Request for Additional Information – Framatome ANP Richland, Inc. Topical Report EMF-2361(P) Revision 0, EXEM BWR-2000 ECCS Evaluation Model, (TAC NO. MB0574)

**Request for Additional Information on Topical Report
EMF-2361(P) Revision 0, EXEM BWR-2000 ECCS Evaluation Model**

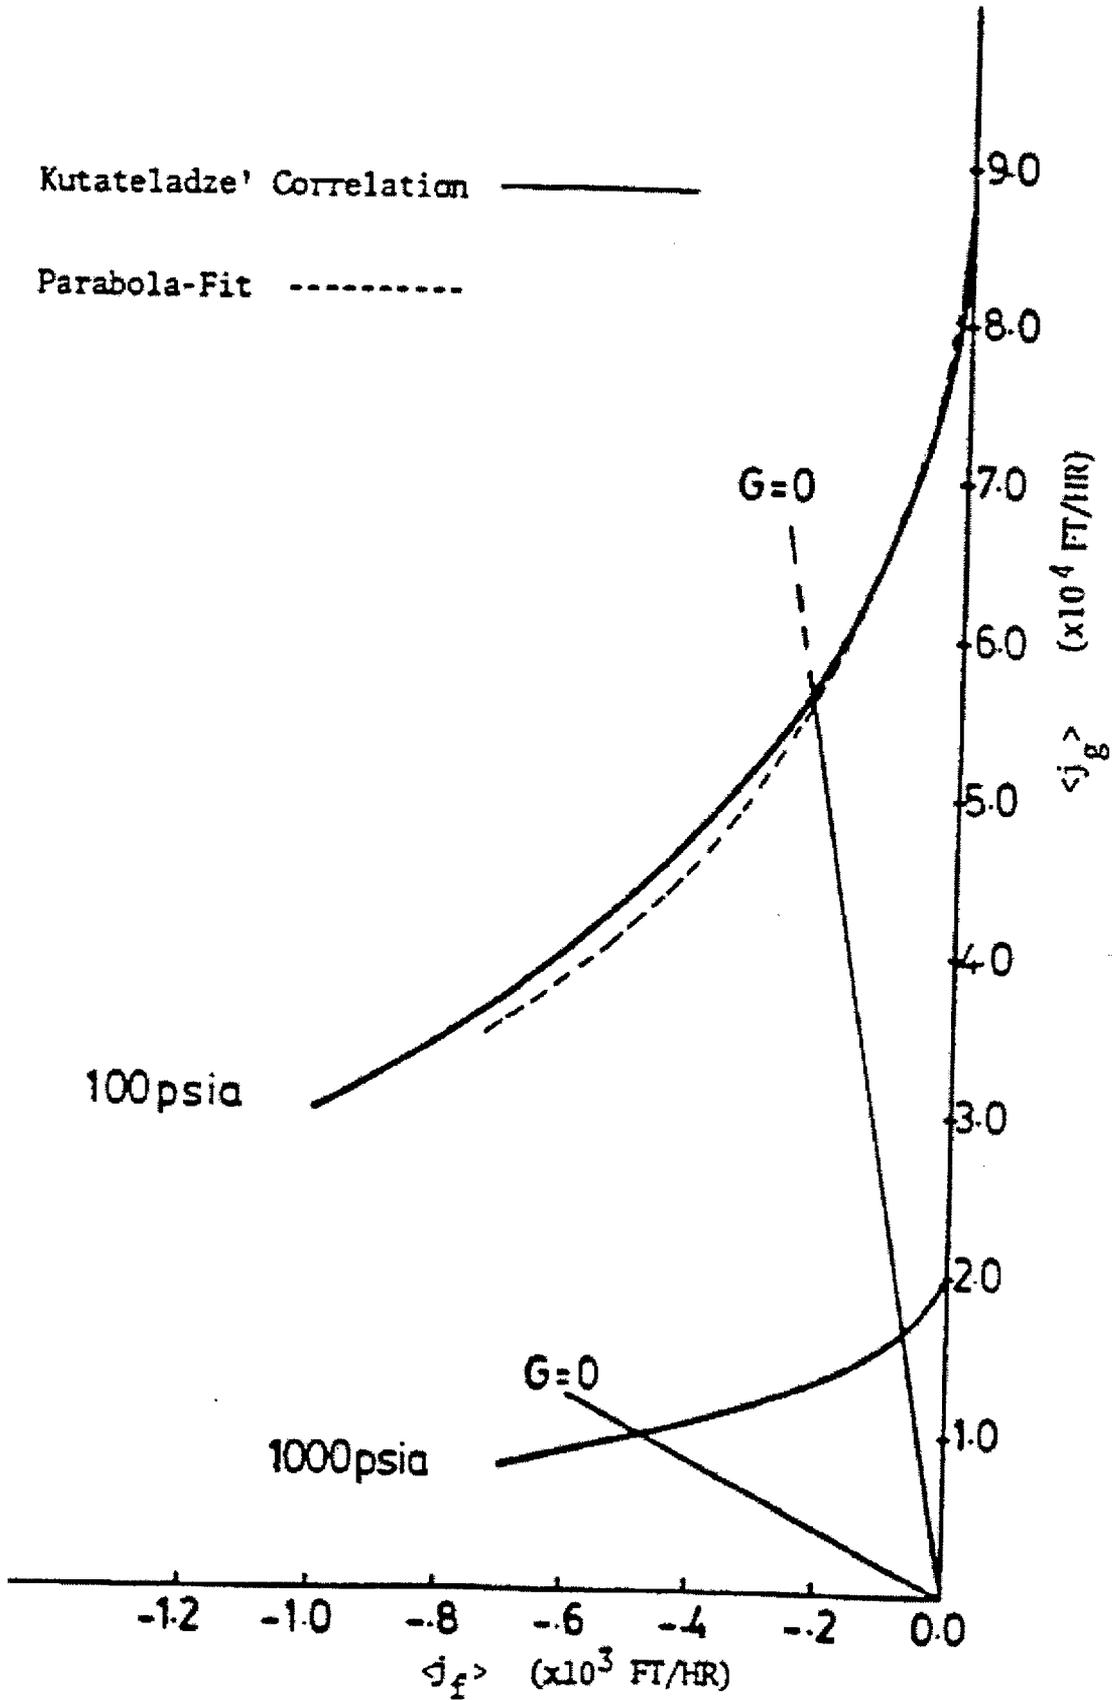
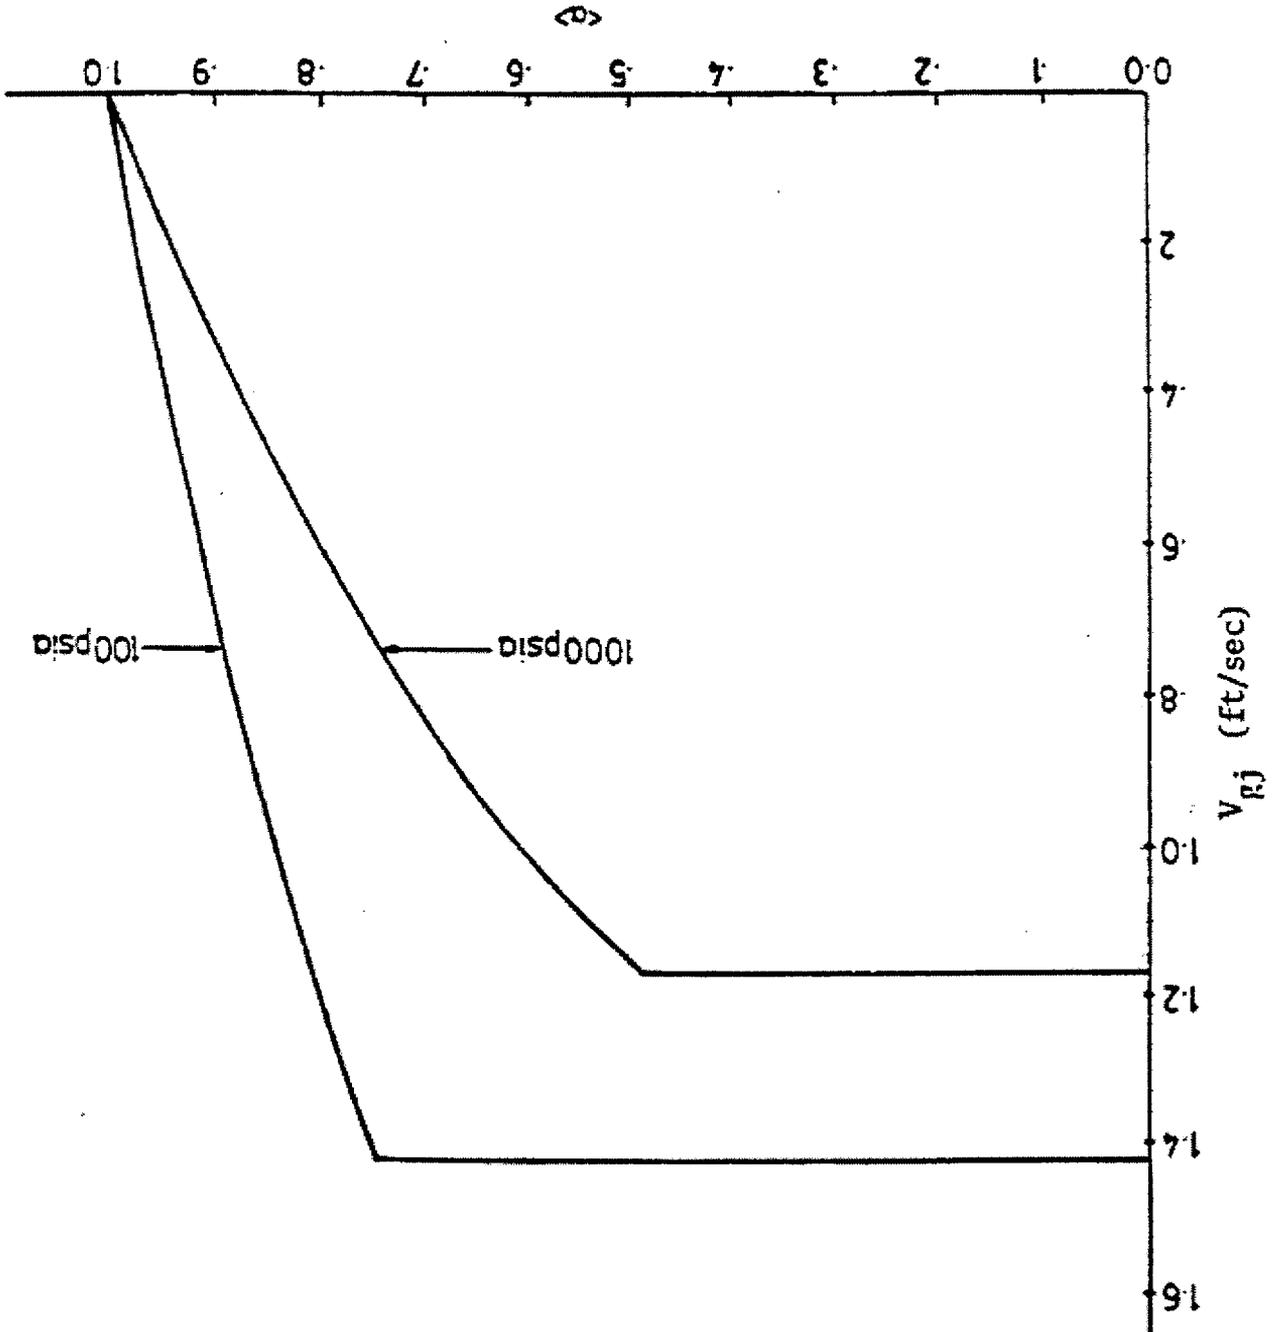
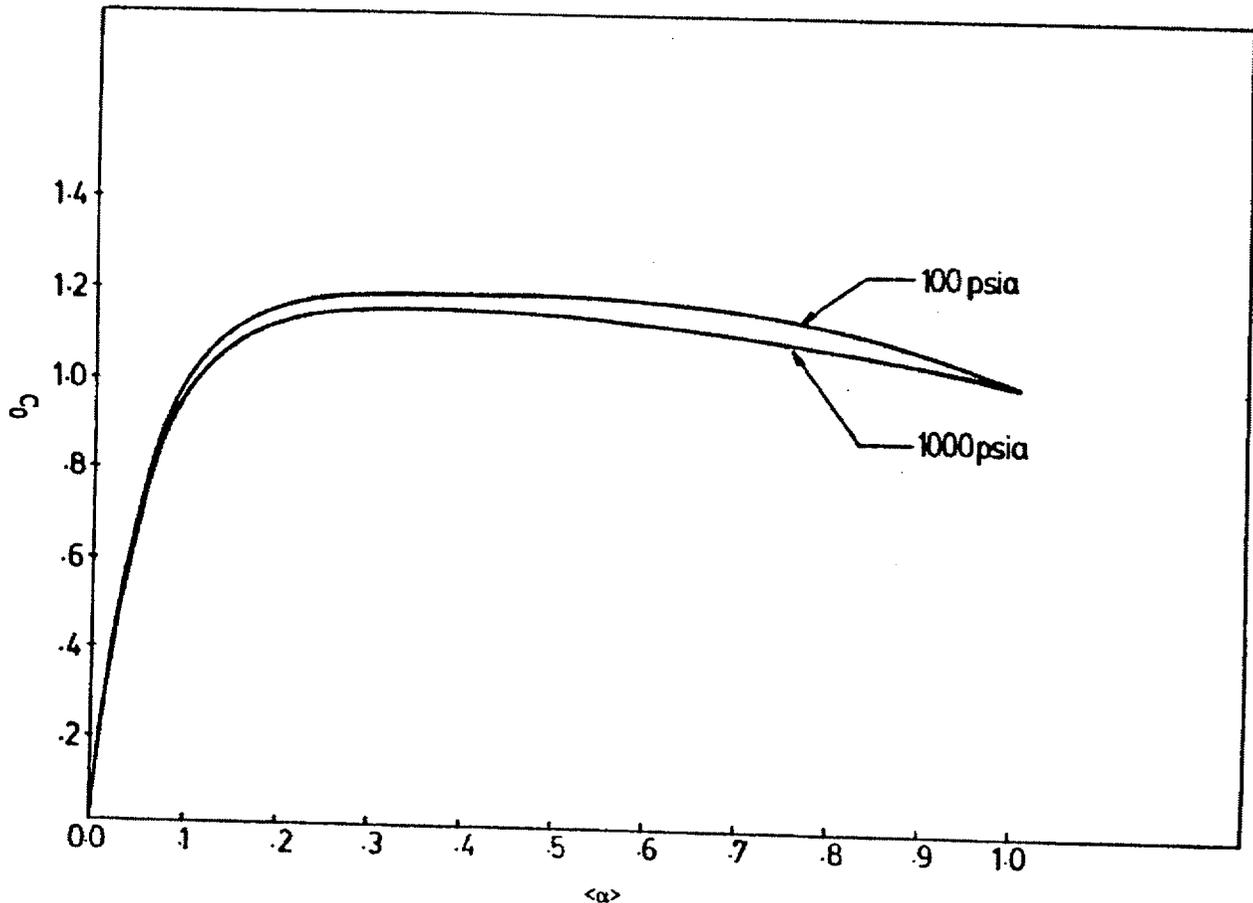
In Figure 3.1 of the report, the effect of drift flux models on void fraction was presented for steady state conditions. The staff requests the applicant to submit comparisons of void fraction distribution predicted by EXEM BWR-2000 with other approved code and test results at intermediate and low pressures also. The pressure should include values typically encountered during refill/reflood phase.

The document NES-486, "The Analysis of Proposed BWR Inlet Flow Blockage Experiments in PBF," describes the analytical development of the Ohkawa-Lahey drift flux model and shows that the drift flux model was designed to provide a smooth and continuous representation for a wide range of pressures (on the order of 100 to 2000 psia) and that it is applicable over the parametric space that is encountered in the RELAX calculations. The following figures from NES-486 show that the correlation is designed to provide a smooth representation of the drift flux from low to high pressure.

The first figure shows a parabolic fit to the data compared to the Ohkawa-Lahey drift flux model and its implementation in the Kutateladze form. This figure demonstrates that the Ohkawa-Lahey drift flux model adequately represents data taken at lower pressures. The second and third figures show the representations of void fraction versus slip velocity and C_o (where C_o is the parameter used in the Zuber-Findley drift flux formulation). These two figures show the behavior of the Ohkawa-Lahey drift flux correlation for both 100 and 1000 psia, for which it was designed. The calculation of C_o and slip velocity are well behaved and have no specific flow regime dependence; they are continuous and stable throughout the operating space to which they are applied.
